## Unit Injector Yoke Hold-Down Bolt Torque Specification CHU, CXU, GR, GU, PI

### FSB 237-020, Unit Injector Yoke Hold-Down Bolt Torque Specification

(October 2017)

W2128267

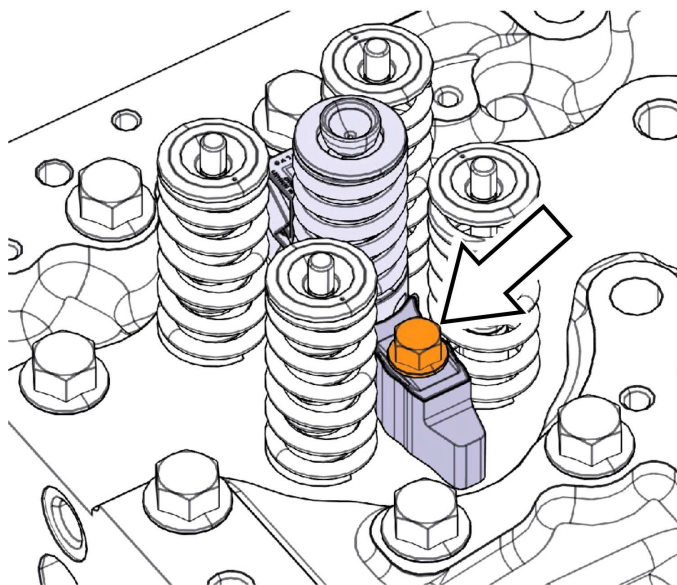
MACK CHU, CXU, GR, GU, and PI trucks built from 2009 to 2017 and equipped with MP7, MP8, and MP10 engines (EM-USA10, EM-USA14, and EM-USA17), will require a new torque specification for the Unit Injector Yoke Hold-Down Bolt. Effective immediately, the torque value in step 4 has changed to 25 +5/-0 Nm (18 +4/-0 ft-lb). See the torque procedure in steps 1 through 5 below. Additionally, the new yoke hold-down bolt torque will be updated in all service procedures, methods, and specification manuals.

- 1 Tighten 20 +5 Nm (15 +4 ft-lb).
- 2 Tighten 180 ±5 degrees.
- 3 Loosen the bolt until the torque is 10 to 15 Nm (7 to 11 ft-lb), back off approximately 150 Degrees.
- 4 Tighten 25 +5/-0 Nm (18 +4/-0 ft-lb).

5 Tighten 90  $\pm$ 5 degrees.
